RE: [EXTERNAL] :COGCC Form 2A review of PDC Energy's Ottenhoff 5N64W29CR location - Doc #401049022

From: Andrews - DNR, Doug [mailto:doug.andrews@state.co.us]
Sent: Wednesday, July 6, 2016 2:25 PM
To: Venessa Langmacher <Venessa.Langmacher@pdce.com>
Subject: [EXTERNAL] :COGCC Form 2A review of PDC Energy's Ottenhoff 5N64W29CR location - Doc #401049022

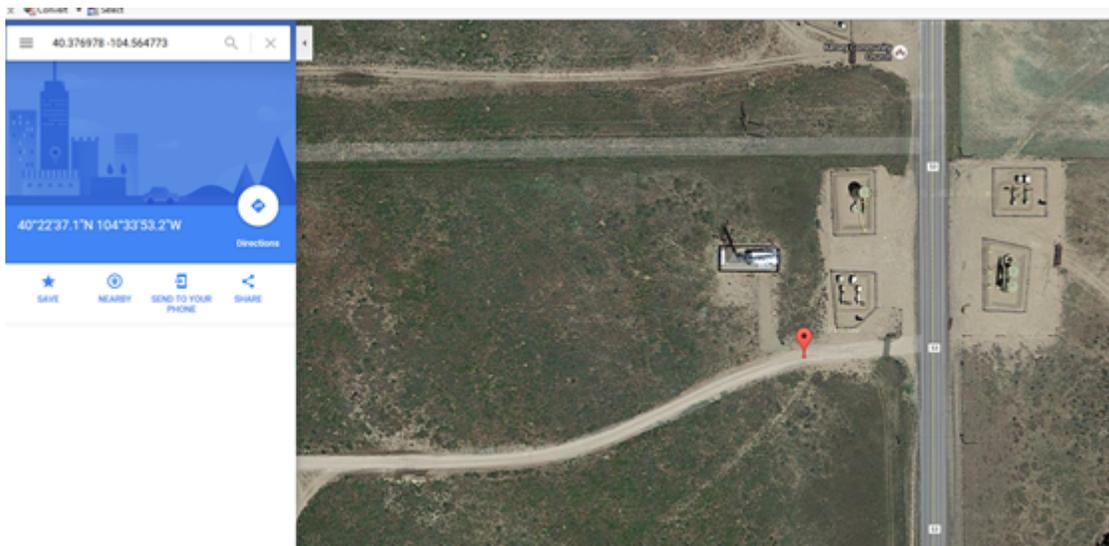
6) Your Reference Area Map lists the Reference Area as being located as Latitude 40.376978 / Longitude -104.564773. When I plot this location it maps as being in the middle of an existing access road. See the attached screenshot from Google Maps. This also agrees with what is shown on your Reference Area Pictures. Per the COGCC's Attachment Guidance on Reference Areas, the Reference Area shall be an area that is undisturbed by oil and gas operations. The chosen Reference Area does not appear to be acceptable as the ground is currently disturbed and we do not want operators to use disturbed ground (in this case a gravel access road) as the reference for setting their reclamation standards. Please provide revised Reference Area Map & Pictures attachments that identifies an area that is currently not disturbed. [Attached](#)
